EL PASO WATER UTILITIES – PUBLIC SERVICE BOARD

ADDENDUM NO. 2

CANAL WATER TREATMENT PLANT FILTER GALLERY IMPROVEMENTS

BID No. 10-23

DEMOLITION SECTION

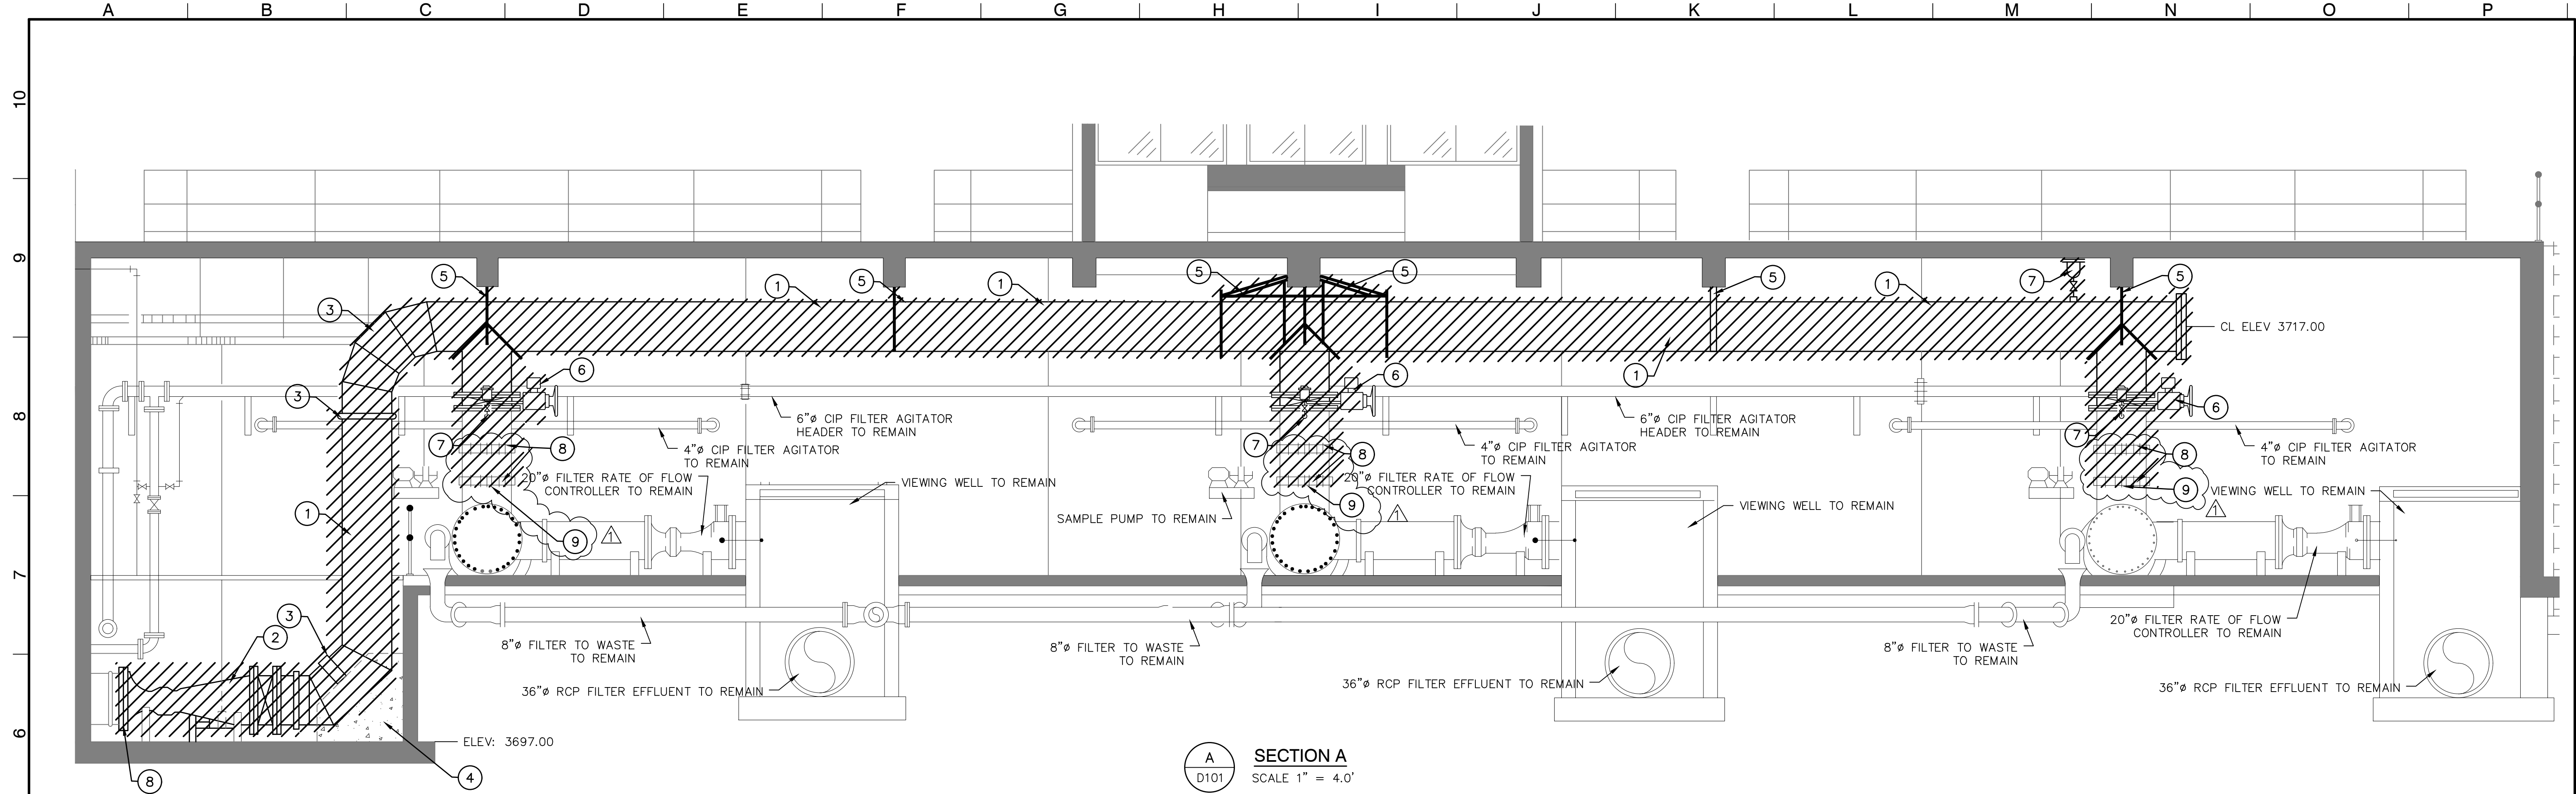
In the Summary of Work Description, Delete Item 4 and Item 6 in their entirety and replace with the following to address the actual number of air release valves indicated on the plans:

ITEM 4. Remove and dispose of approximately 125 linear feet of existing 30-inch cement lined steel pipe to include fittings and supports, **FOUR (4) ½-inch air release VALVES**, four (4) 30-inch butterfly valves, and one (1) 30-inch venturi-type rate of flow controller.

AMENDED NOTATIONS PER ADDENDUM NO. 2

DRAWING NUMBER
M101
SHEET No. 7 OF 34

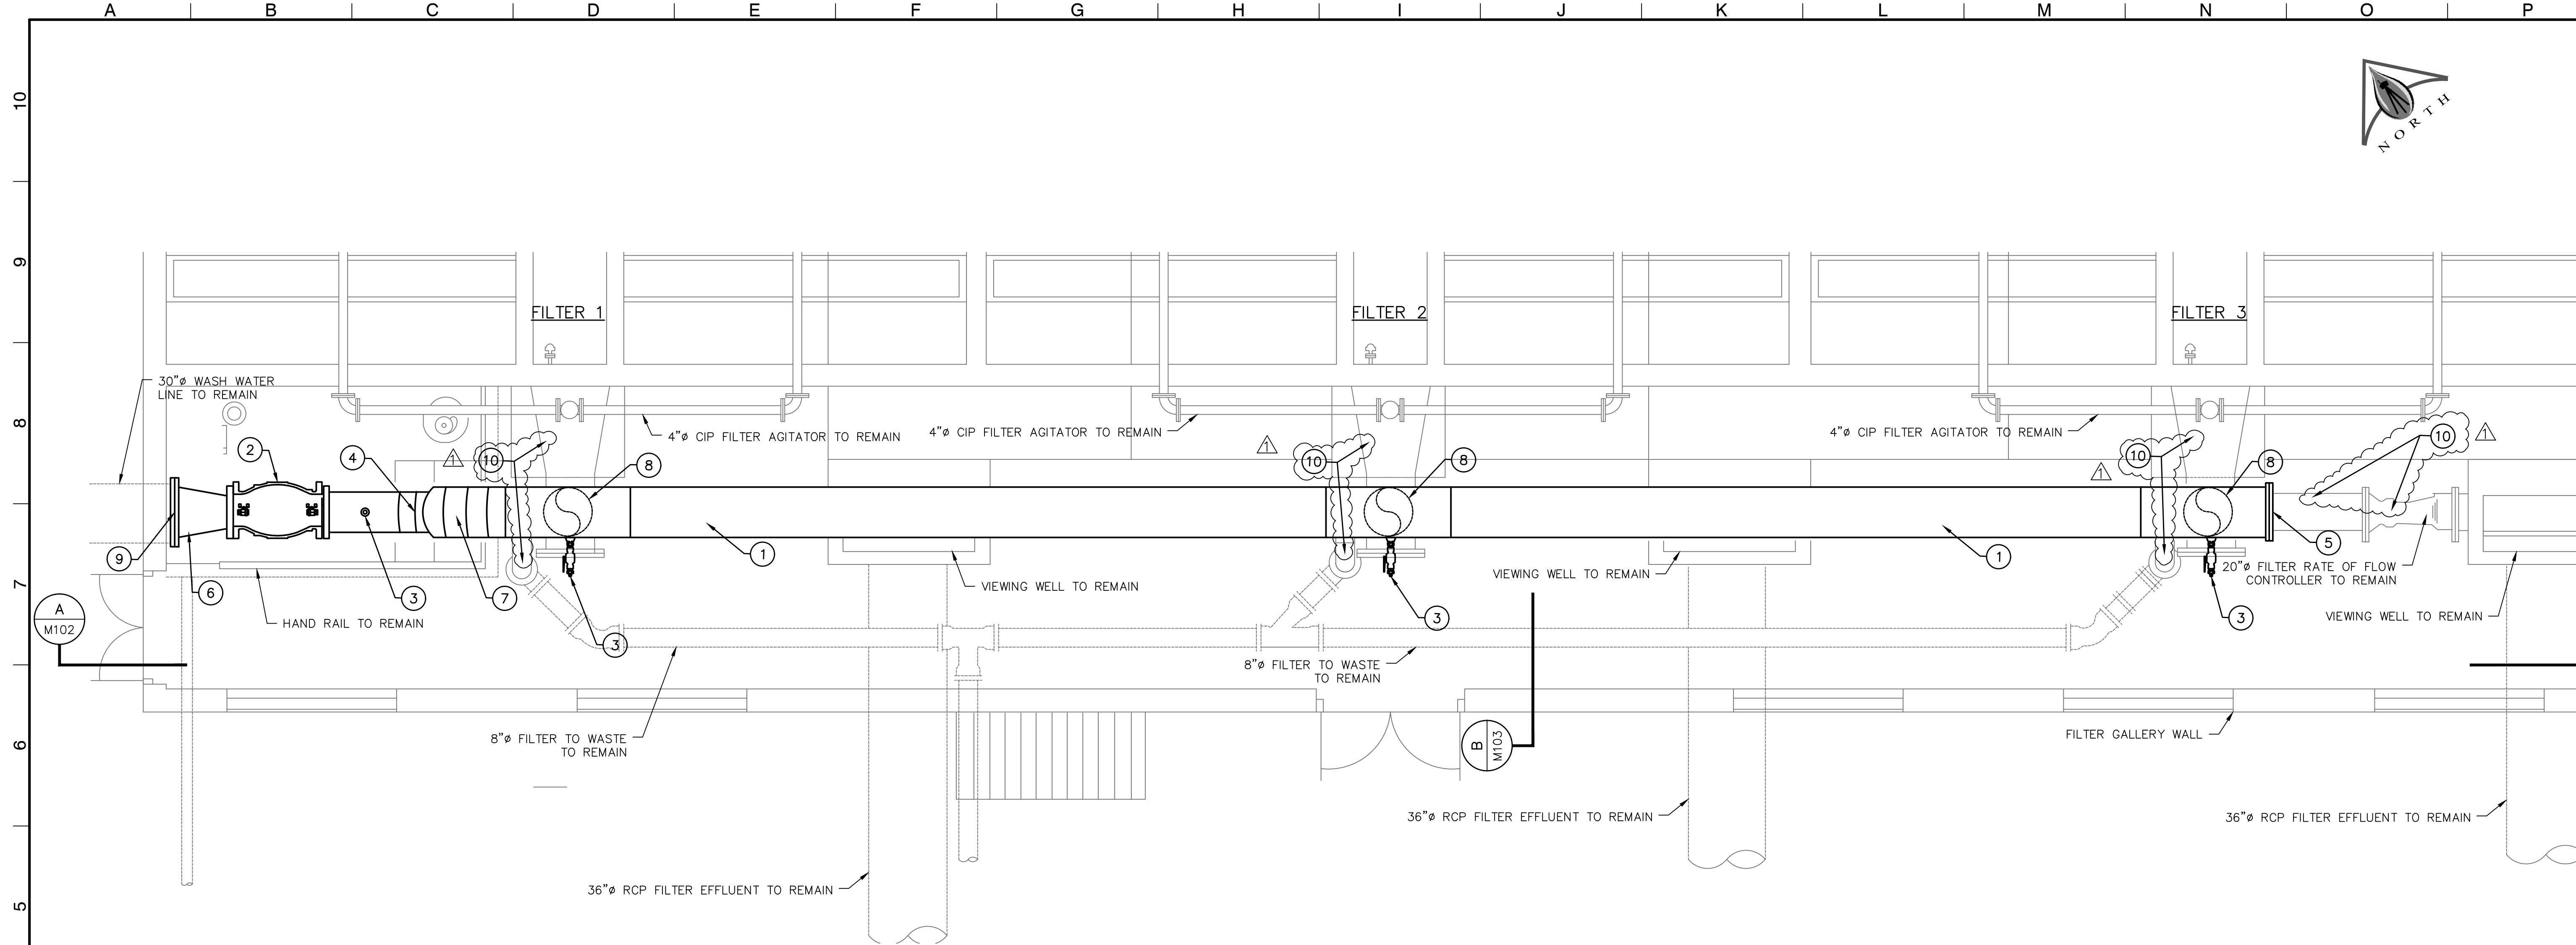
ITEM 6. Furnish and install one (1) 24-inch rate of flow control valve, three (3) 30-inch motor actuated butterfly valves **and FOUR (4) ½-inch air release VALVES**.

DATE	REVISIONS	BY
02/17/23	AMENDED NOTATIONS PER ADDENDUM NO. 2	RGB

CANAL WATER TREATMENT PLANT FILTER GALLERY IMPROVEMENTS	DRAWING NUMBER
SHEET TITLE	
PIPE HANGER DETAILS	M104
	SHEET No. 10 OF 34

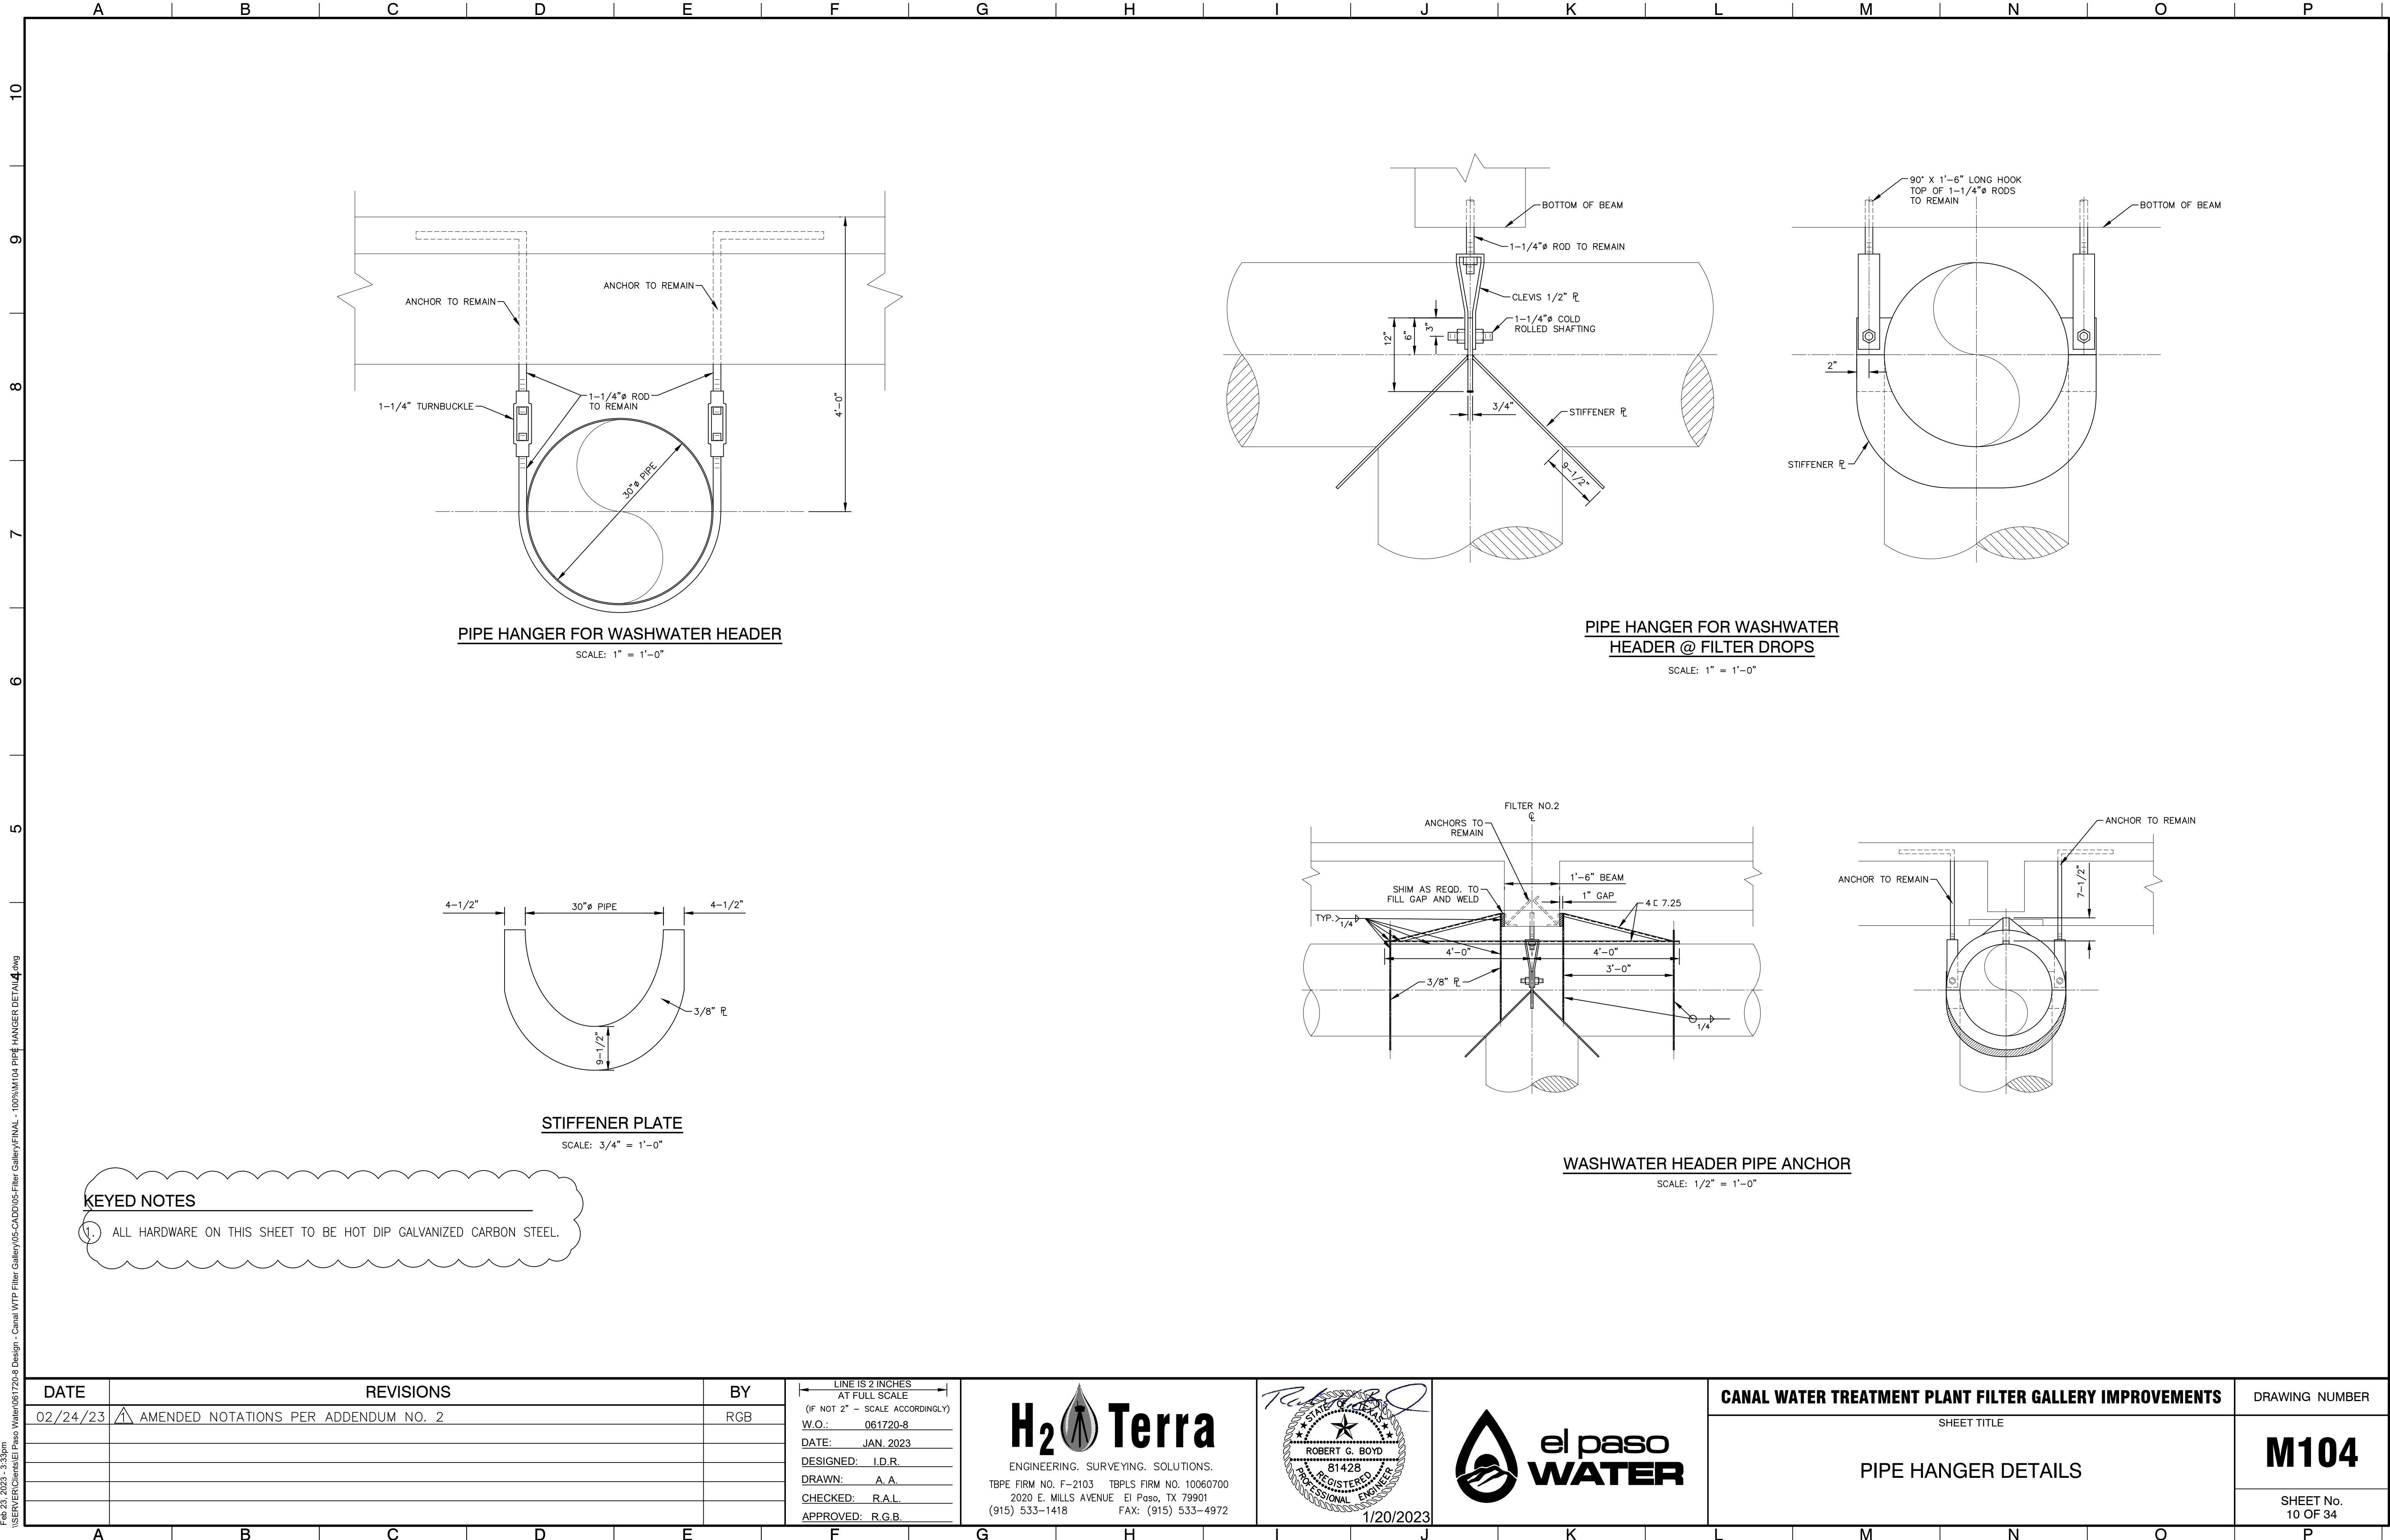
Q4. Plan Sheet G3, general note #7 requires all Hardware to be 316SST, unless otherwise noted. The Hanger Material shown on Plan Sheet M104 (Turnbuckle, Clevis, Nuts, etc.) has no notes otherwise, per General Note #7 these should be 316SST. Will 316SST be compatible with existing material? What material should hanger accessories be?

A. See note revised Sheet M104.
